Access Compliance Report

Public Rights-of-Way

(Curb Ramps)

Intersection ID: 10040202	Main Street: TYVOLA_RD	Cross Street: N/A	Location: SW
ADA ID: CBECA09A15C7	Ramp Type: PerpDiag	Initial Pass/Fail: Fail	Overall Compliance: No
Severity Score: 33.75			
Codes/Mitigation Info/Possible Solution		Field Measurements/Component Compliance

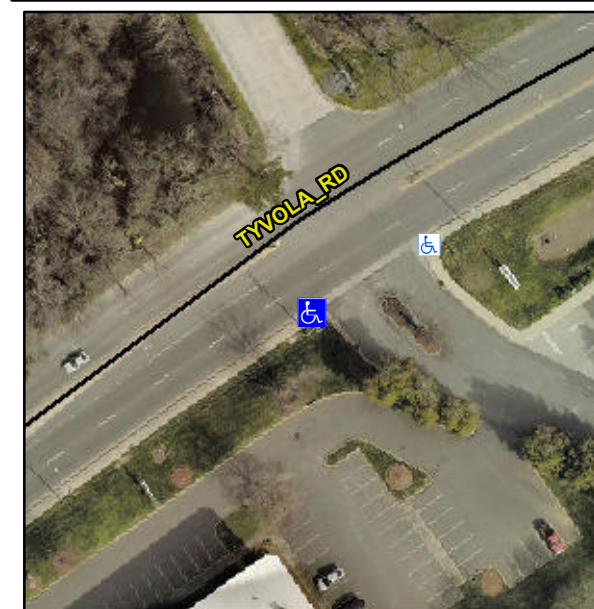
R304.5.1, R304.2.2, R304.5.3

Compliance	Description	Data	Compliance	Description	Data
N/A	Ramp Length (in)	63.5	No	Ramp Slope (%)	9.9
No	Ramp Width (in)	37.0	No	Ramp XSlope (%)	5.3
N/A	Flare Type LT	N/A	N/A	Flare Type RT	N/A
N/A	Flare Slope LT (%)	N/A	N/A	Flare Slope RT (%)	N/A
N/A	Flare Traversable LT?	N/A	N/A	Flare Traversable RT?	N/A
N/A	Landing Length (in)	N/A	N/A	DWS Provided?	N/A
N/A	Landing Width (in)	N/A	N/A	DWS Contrast?	N/A
N/A	Landing Slope (%)	N/A	N/A	DWS Length (in)	N/A
N/A	Landing X Slope (%)	N/A	N/A	DWS Full Width?	N/A
N/A	Landing Curb? (Y/N)	N/A	N/A	DWS Offset (in)	N/A
N/A	Shared Landing?	N/A			
N/A	Gutter Ponding?	N/A	N/A	Gutter Slope (%)	N/A
N/A	Gutter Lip Ht (in)	N/A	N/A	Gutter X Slope (%)	N/A
N/A	Painted X Walk1?	No	N/A	Painted X Walk2?	No
	X Walk 1 Direction	To NE		X Walk 2 Direction	To NW
N/A	X Walk 1 Width (in)	N/A	N/A	X Walk 2 Width (in)	N/A
	X Walk 1 Slope (%)	1.4		X Walk 2 Slope (%)	3.3
	X Walk 1 X Slope (%)	3.2		X Walk 2 X Slope (%)	2.5

N/A	Ramp inside XWalk1?	N/A	N/A	Ramp inside XWalk2?	N/A
	Road Slope (%)	2.4	N/A	Clear Space?	N/A
	Road X Slope (%)	2.5	N/A	Clear Space to XWalk (in)	N/A
N/A	Any Obstructions?	N/A	N/A	Storm Grate/Utility Hazard?	N/A
	Obstruction Type			Storm Grate/Utility Type	
		N/A			N/A
			Yes	Surface Condition? (G/P)	Good

Remove & Replace Curb Ramp With Two New Directional Ramps or Equivalent.
